MEMORANDUM

SUBJECT: East Grand Avenue Overlay District Zoning Study – Public Testimony and Revised Proposed Amendments

TO: Planning Commission

DATE: May 10, 2024

IMAGE B- (2x) 2-bed & (2x) 1-bed units

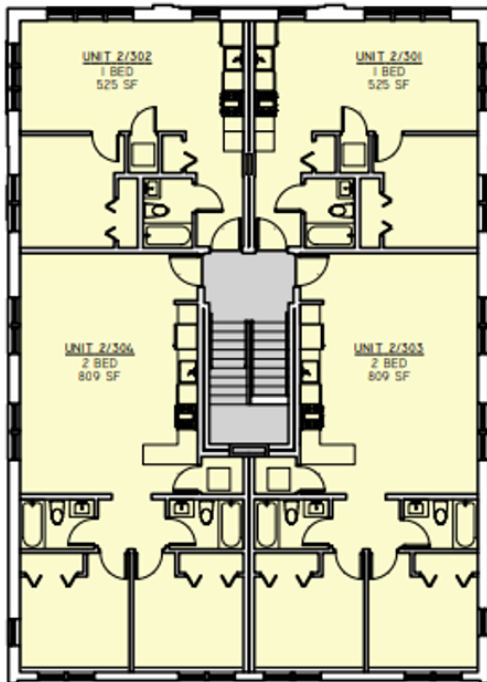
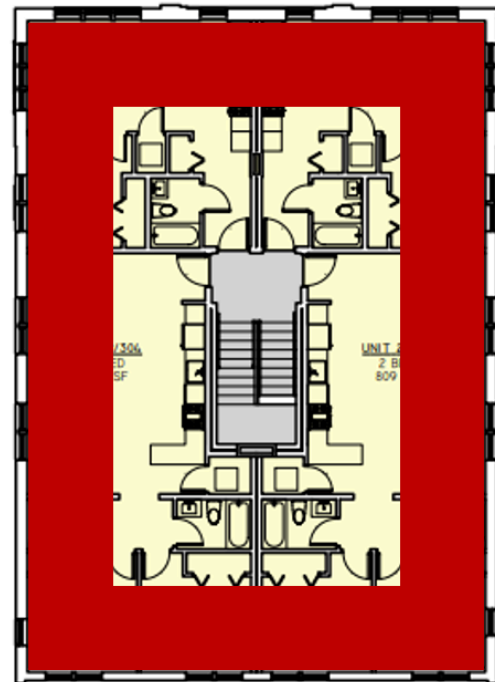
Image B on the left below shows the 3rd floor of the building without stepbacks includes two 2-bed units and two 1-bed units . **Image C** on the right shows the stepbacks as proposed would result in the loss of >50% of the built square footage and two 2-bed units. **Under these conditions, no project would be built.**

In a development with the stepbacks pictured on the right:

- The cost of land, design, utilities, fire protection and facade would stay the same
- The cost of framing would increase with added complexity
- The rent generated by the project, which is required by lenders and investors, would decline due to the loss of multiple units

1. **Sustain Saint Paul's highest-priority proposed change, Side & Rear Yards:** Stepbacks should only apply to front yards, or corner-side yards on projects with >200' of street frontage (e.g. 150' typical lot depth + >50' Grand Ave frontage). Rear yards should not have any step back requirement.

3. **Change the Stepback Threshold:** Increase the current 30' height threshold triggering a 10' stepback to a 40' threshold.

** 800 Grand Ave, 3 stories (0 setback from both)*

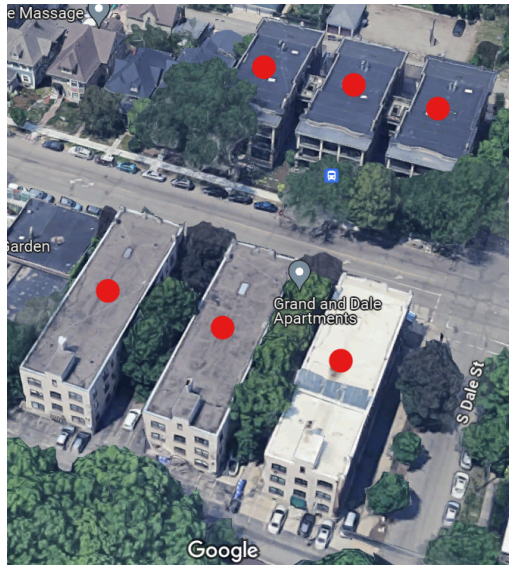
Appendix: Examples of existing Grand Avenue buildings east of Virginia that would be prohibited to build under the current proposed overlay district

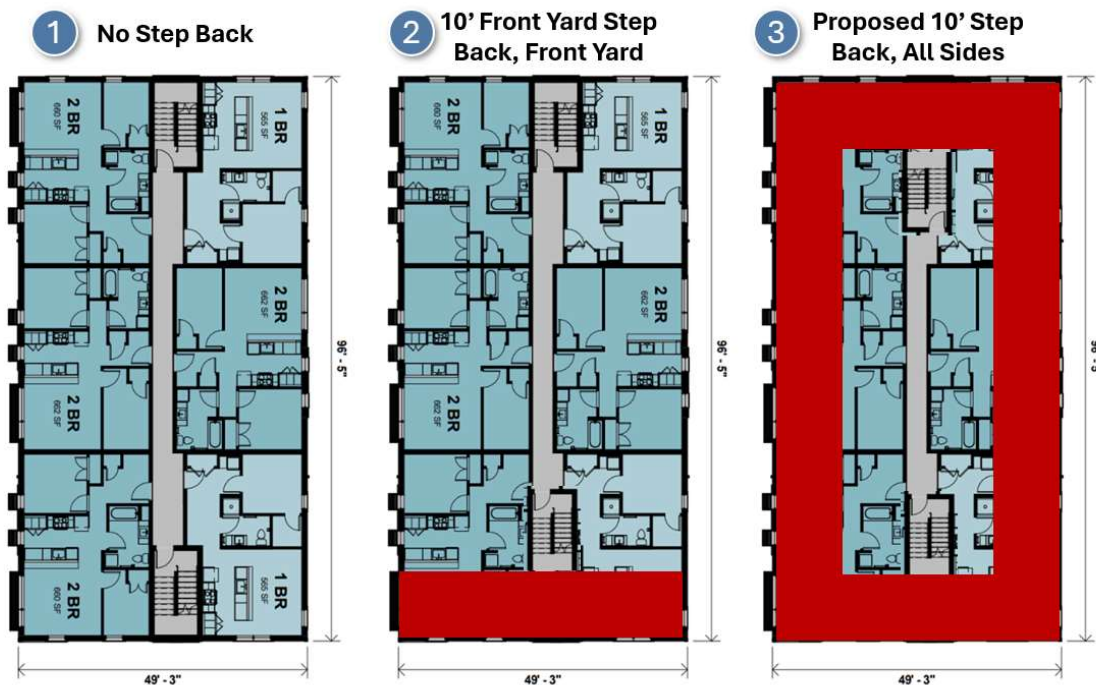
Image #3 below shows the current stepback proposal of 10' on all sides of the building. The 4th floor is mostly hallway & stairs, with poorly functioning, bowling-alley shaped units. In this scenario, no 4th floor would be attempted. **With only 3 stories of units, and the high cost of land on Grand Avenue, the project would be economically inviable. No bank or investors would fund it.**

In Image #2, we see that having a **10' step back on just the front yard** of the building **would eliminate 2 entire homes**. The loss of these units still **make the project economically inviable**.
